PROJECT NAME: GREENWAY ESTATES

PROJECT NUMBER: 2023040043

APPLICATION: IMPROVEMENT PLAN #31022

Sheet No.
C009
of
C010

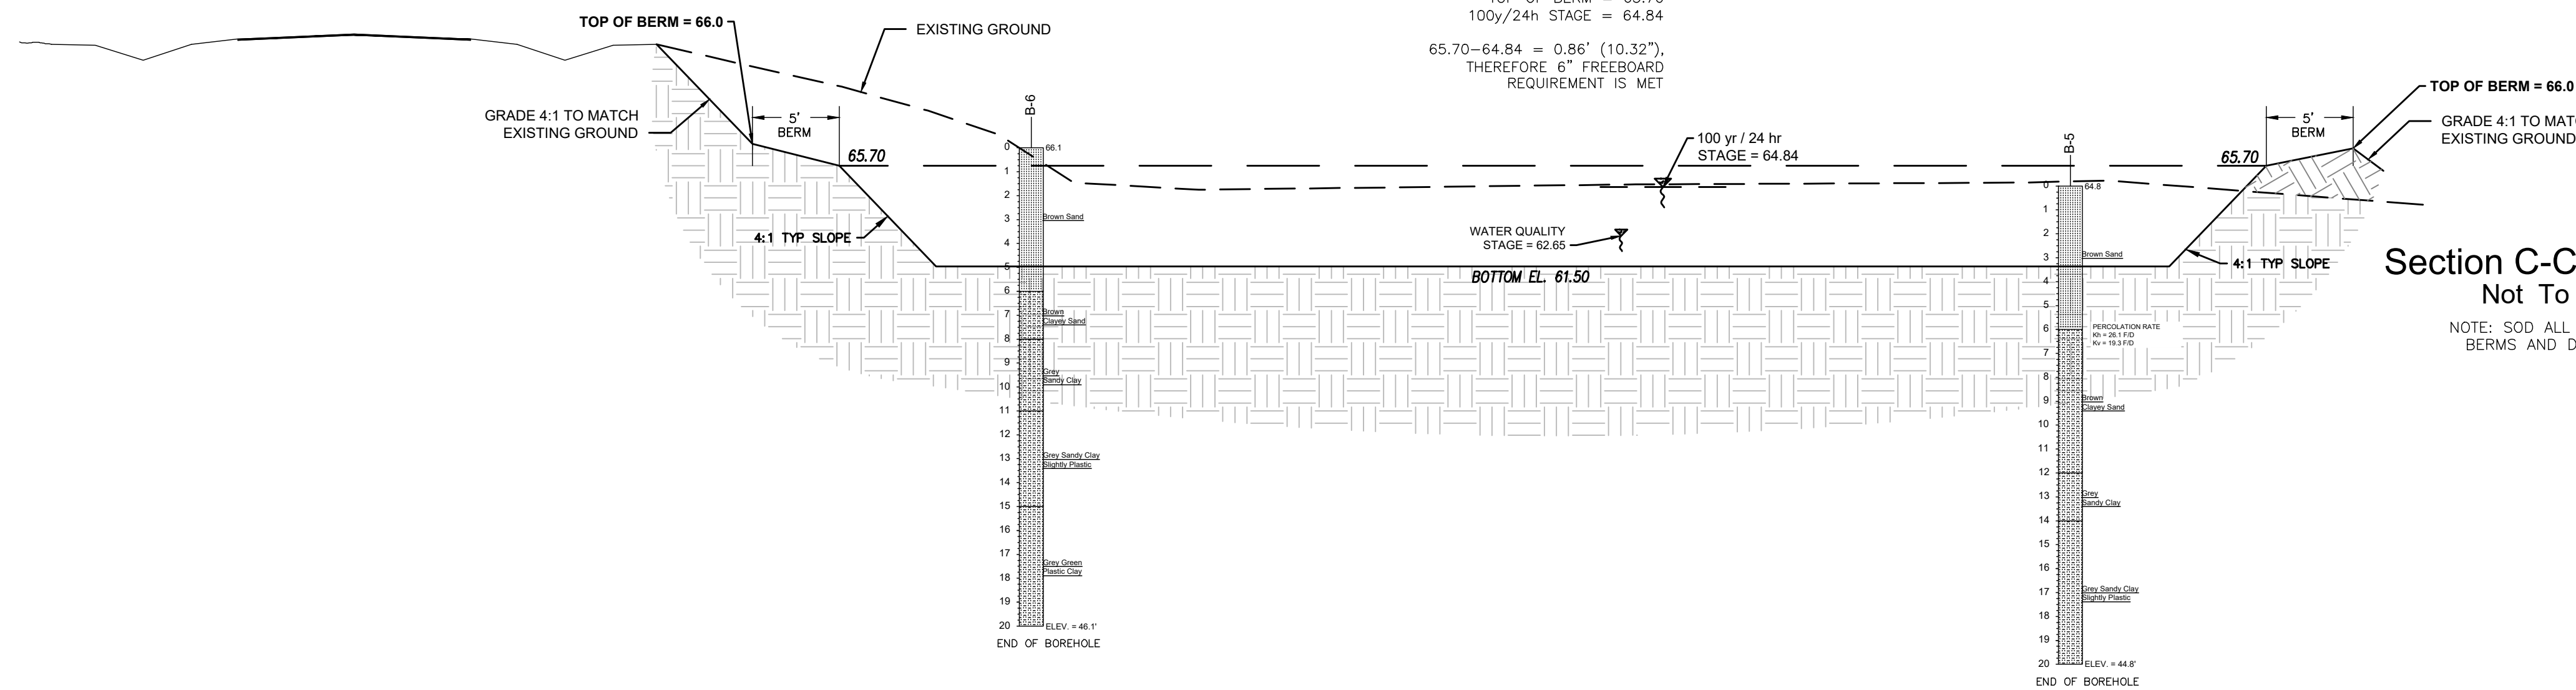
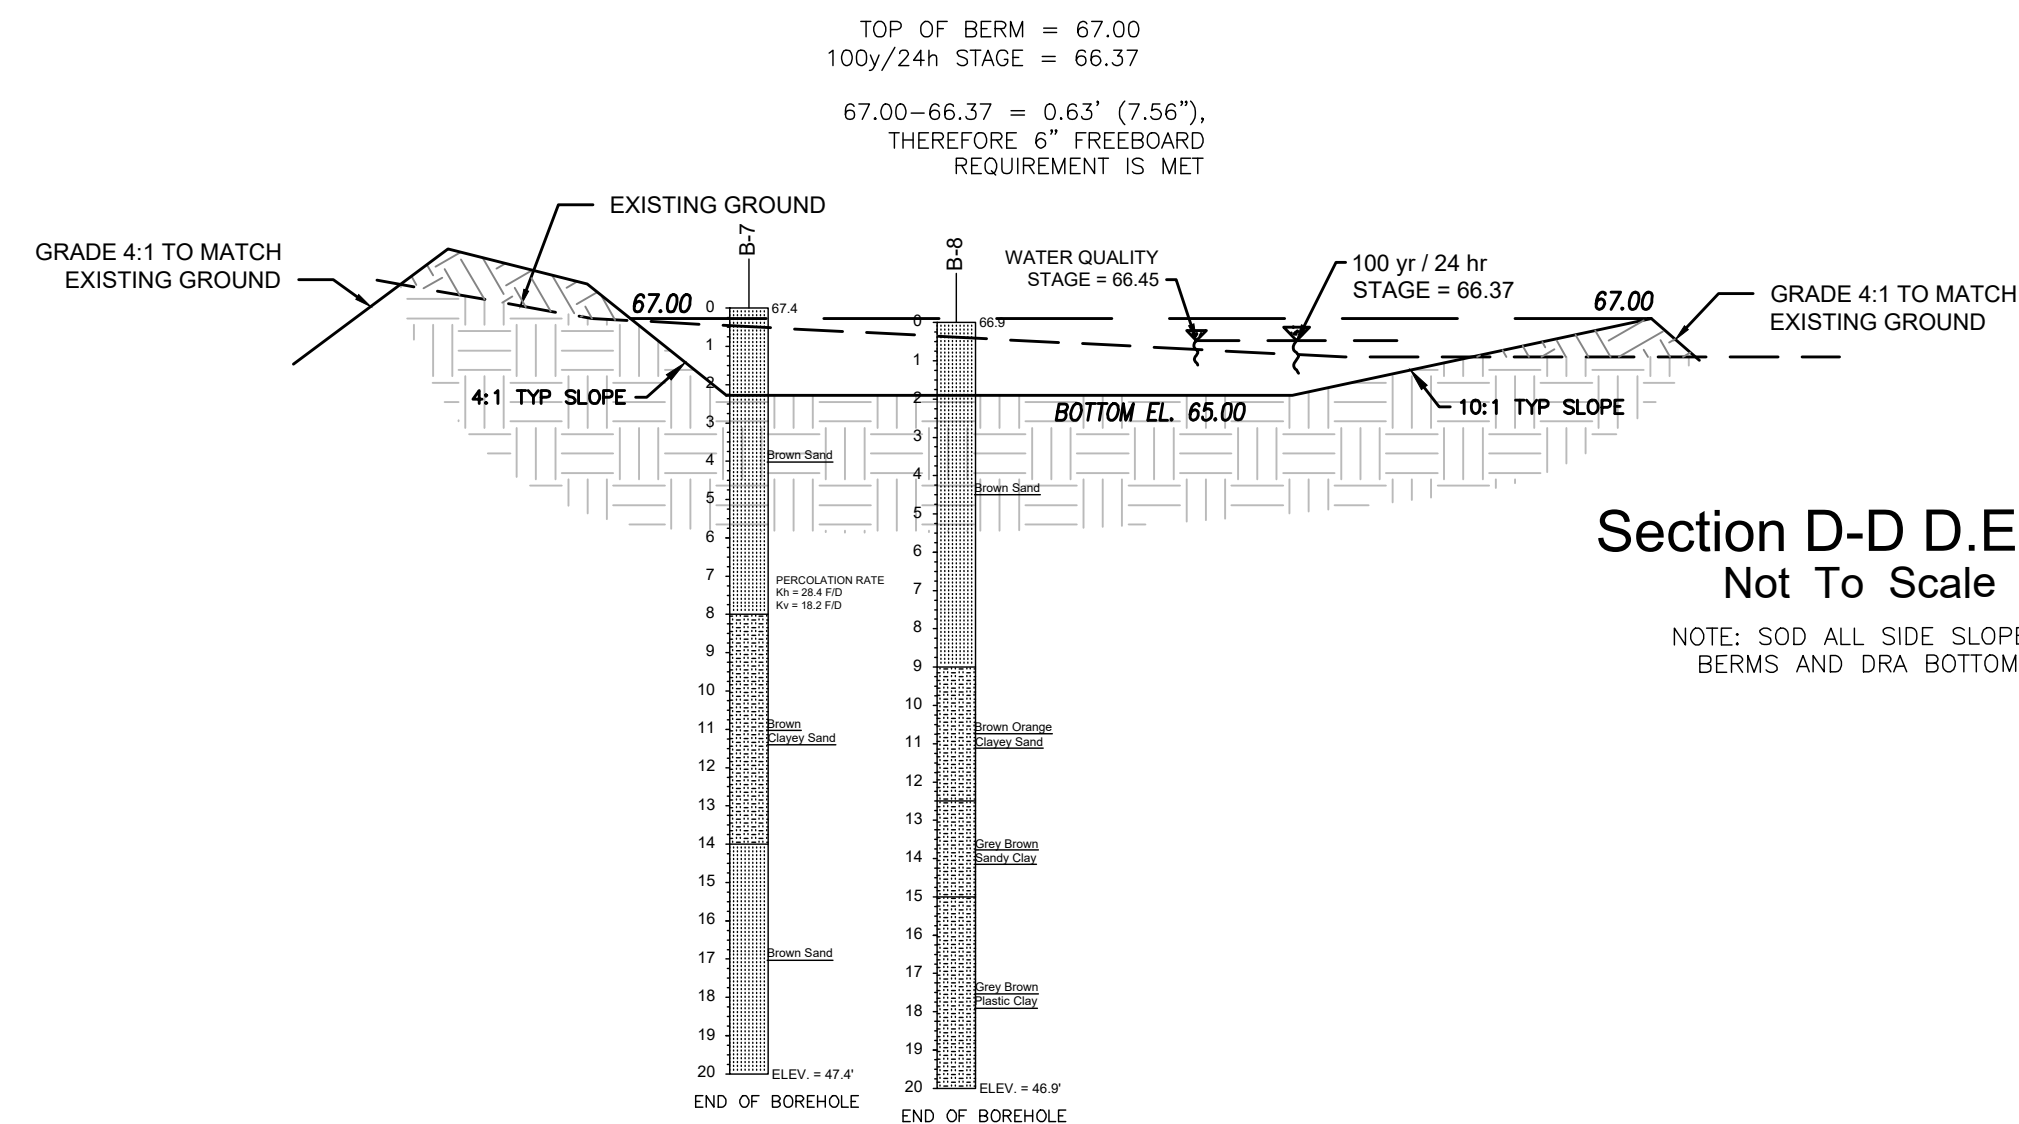
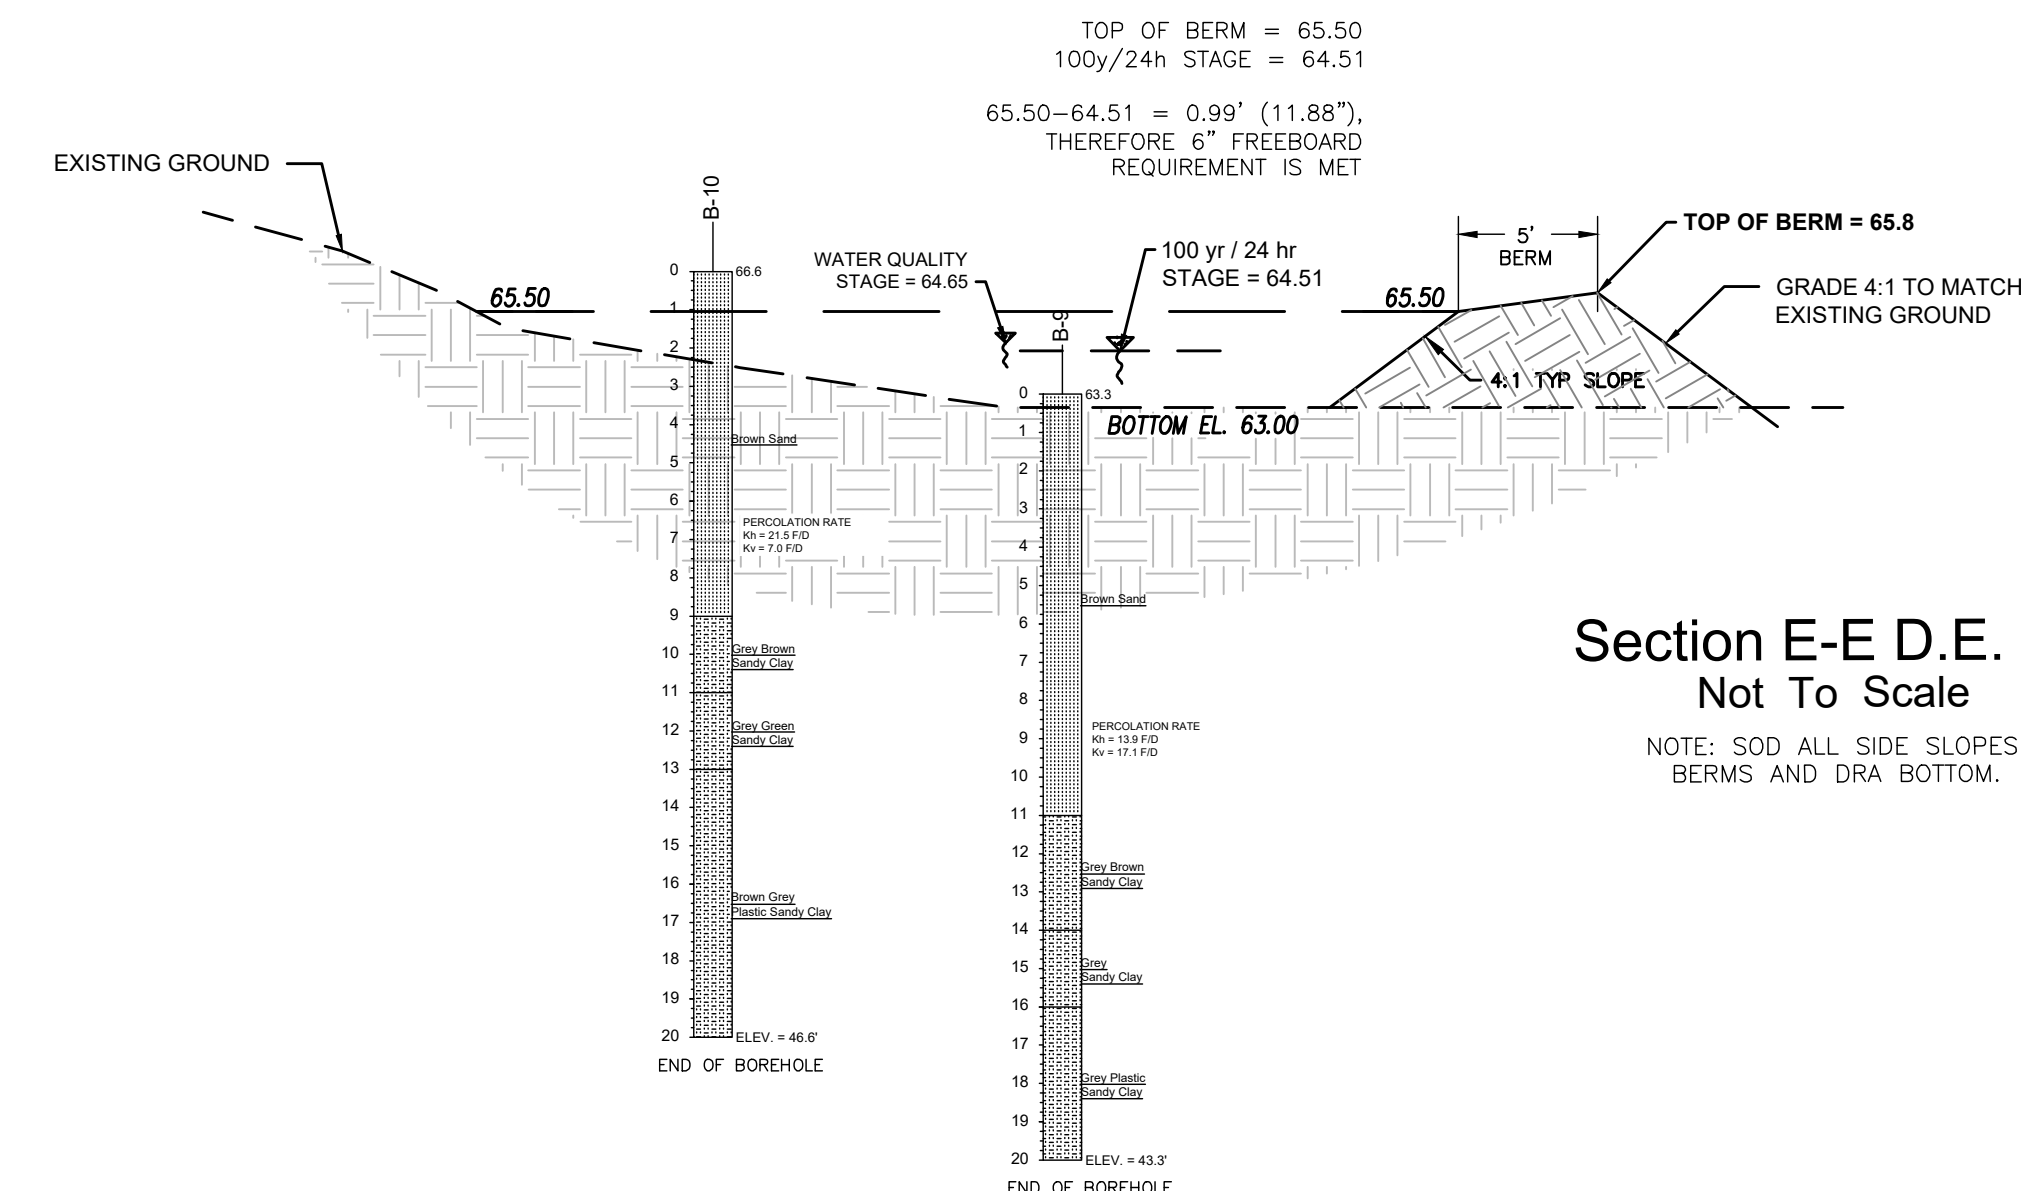
REMARKS: (1) Please update DRA cross sections to include the estimated seasonal high-water elevation, (2) Please add the following note with the pond cross section: "A minimum of three feet of unconsolidated soil material shall be provided between the surface of any limestone bedrock and the bottom and sides of any stormwater facility." (3) Add coordinates or dimensions to the major pond components (changes in alignment, corners, etc) for constructability.

- 32 DEPARTMENT: ENGDRN - STORMWATER REVIEW
REVIEW ITEM: 6.13.9 - Grading Criteria
STATUS OF REVIEW: NO
REMARKS: (1) The berm being created on the north side of DRA 3.0 is shown to have a top elevation of 66.0 on the cross section. This berm is filling a natural area that is around elevation 64. Per the pond cross section the top of the berm is to be graded down to finished grade at a 4:1. Please confirm there is enough room to accommodate this grading within the developing parcel and will not extend onto adjacent property. The scale of the grading plan makes it difficult to verify. (2) The berm being created on the east side of DE 5.0 is shown to have a top elevation of 65.8 on the cross section. This berm is filling a natural area that is

around elevation 62. Per the pond cross section the top of the berm is to be graded down to finished grade at a 4:1. Please confirm there is enough room to accommodate this grading within the developing parcel and will not extend onto adjacent property. The scale of the grading plan makes it difficult to verify. Also, for this parcel there appears to be existing trees/bushes along the property line. Please confirm the fate of this vegetation with the proposed grading.
